DAILY FIELD REPORT

Date: 12/2/10
Project: 62 Cumberland Ave 3-Unit
Project #: 14472
Site Contacts: Mike White - Island Carpentry
Purpose of Visit: Rebar inspection and concrete testing services.

Location: Line 1 at Line C.9

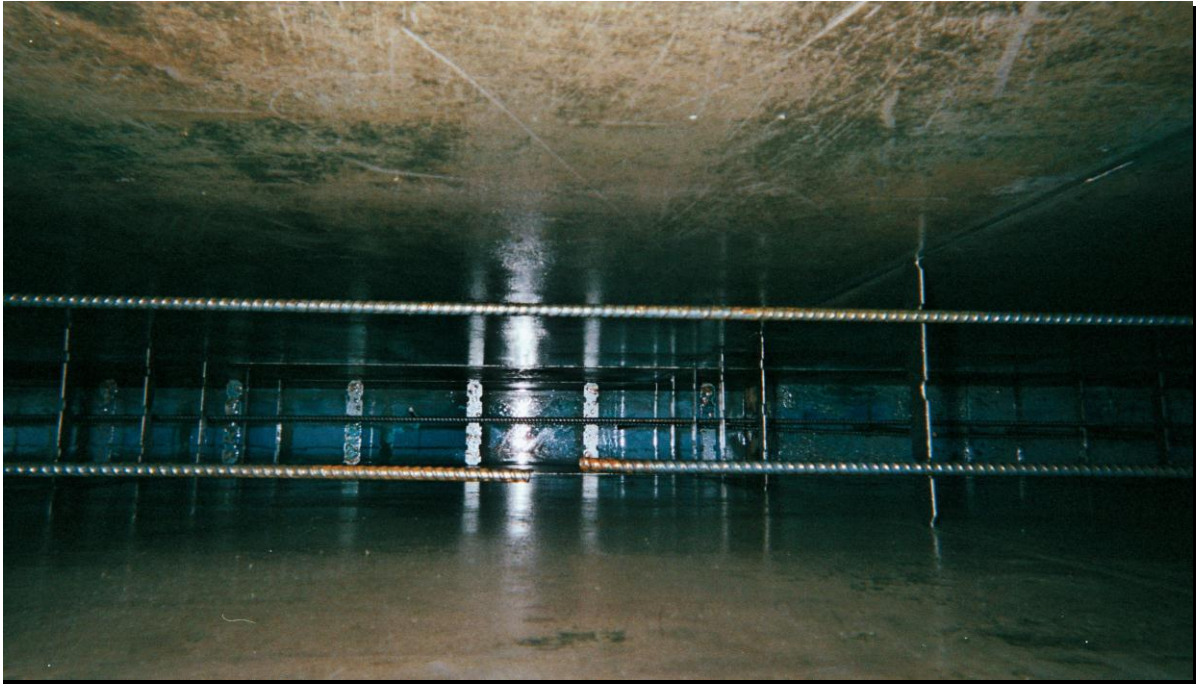
Lap/Splice length meet minimum requirements of specifications.: Vertical Horizontal
Describe: _____ Hz. Lap and setup inconsistent w/ plans

Vertical bar placed at interior of corner, inconsistent with C3/S3.0
Missing upper and lower horizontal interior and exterior bar laps.

Location: Line 3 at line A.4

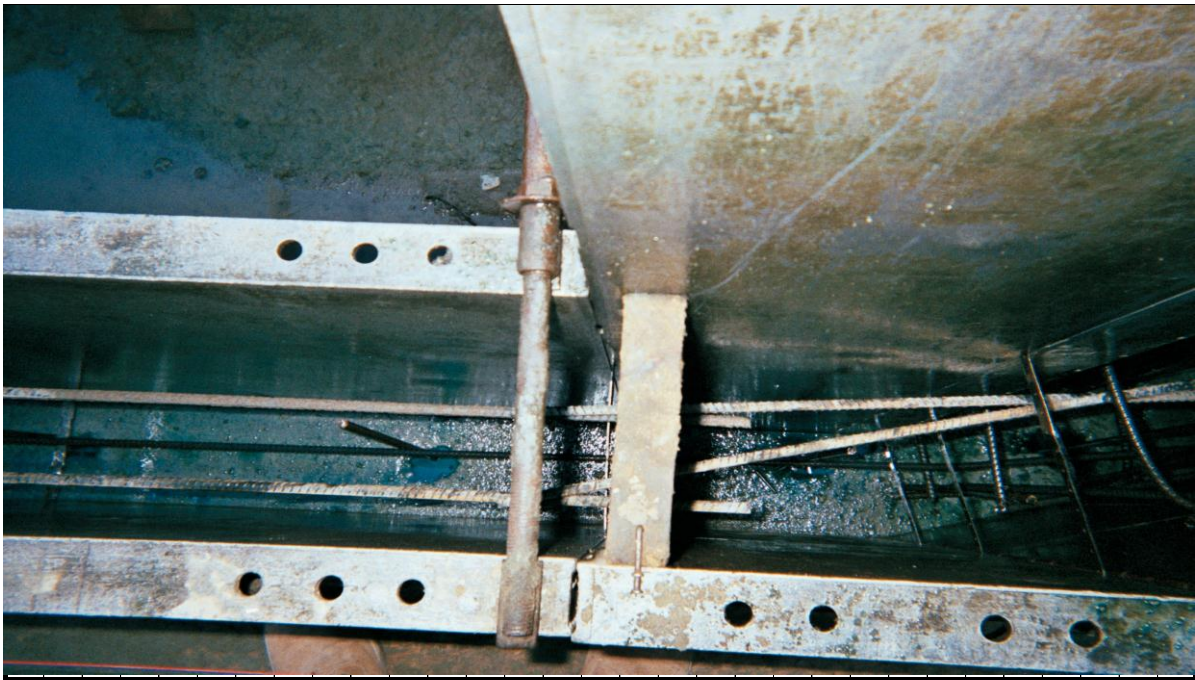
Lower bars around corner inconsistent with plan.
Lower bar not tied to vertical reinforcement.

Location: Line 4.5 at line D off of Pier

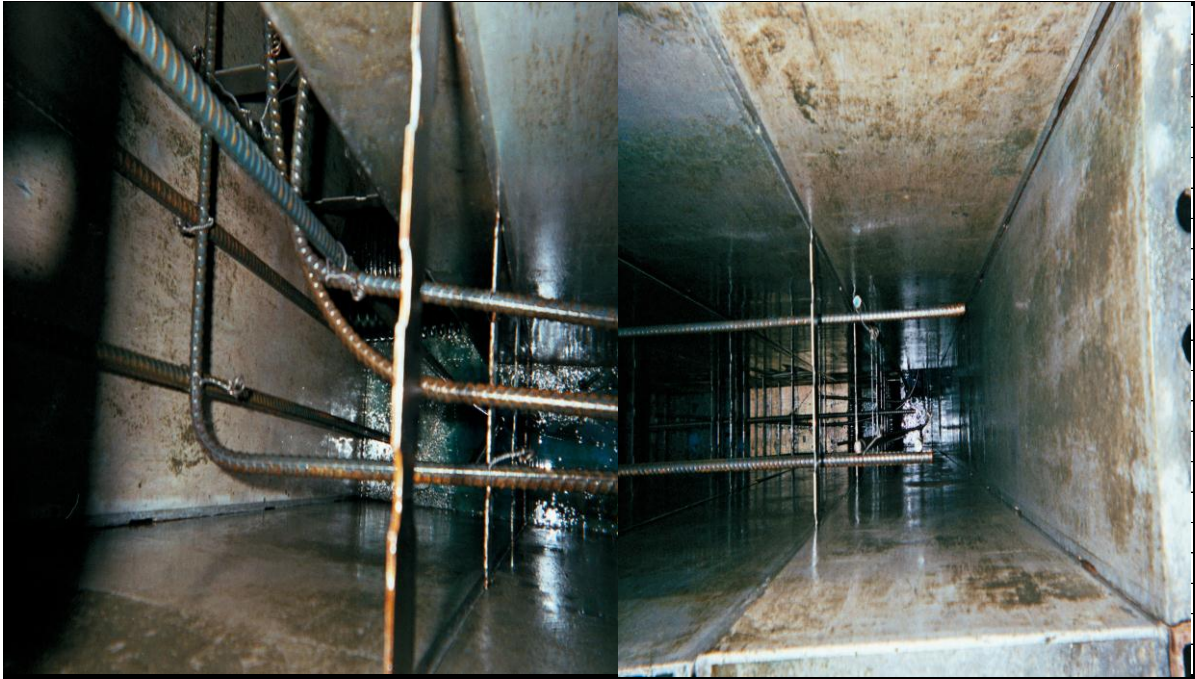
Lap/Splice length meet minimum requirements of specifications.: Vertical Horizontal
Describe: Hz lap approximately 6 to 8 inches

Horizontal lap inconsistent with plan. E.9/S1.0

Location: Line 11 at line A corner

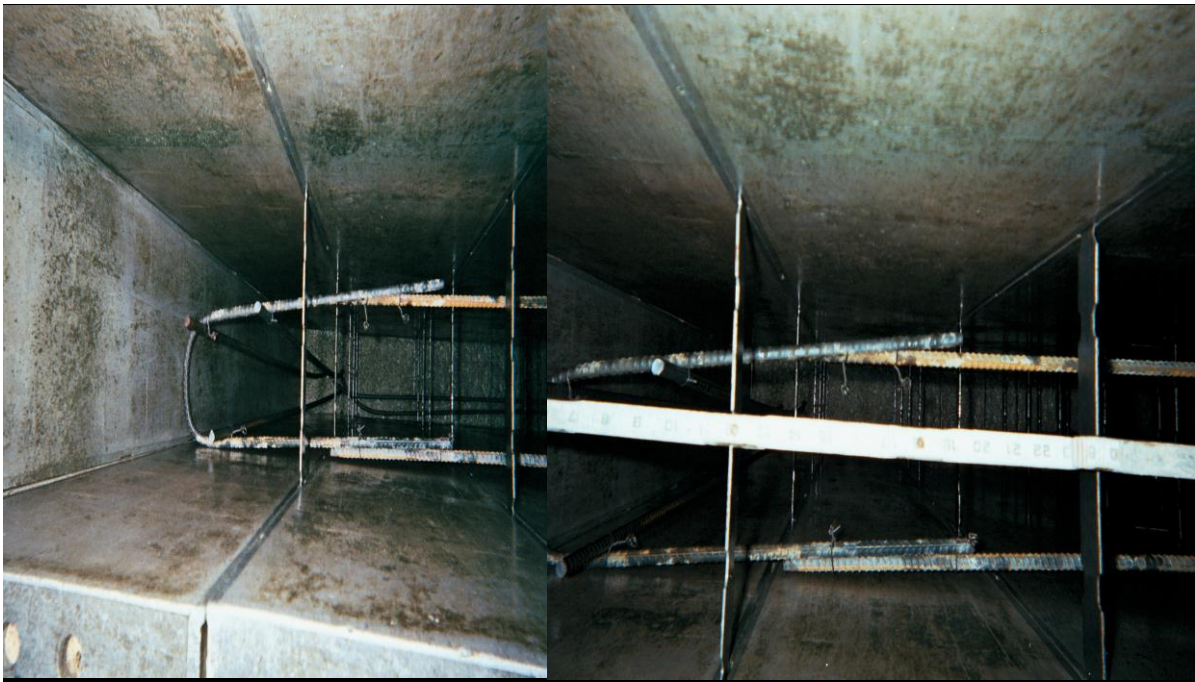
Corner vertical and horizontal bars placement inconsistent with plan. C3/S3.0
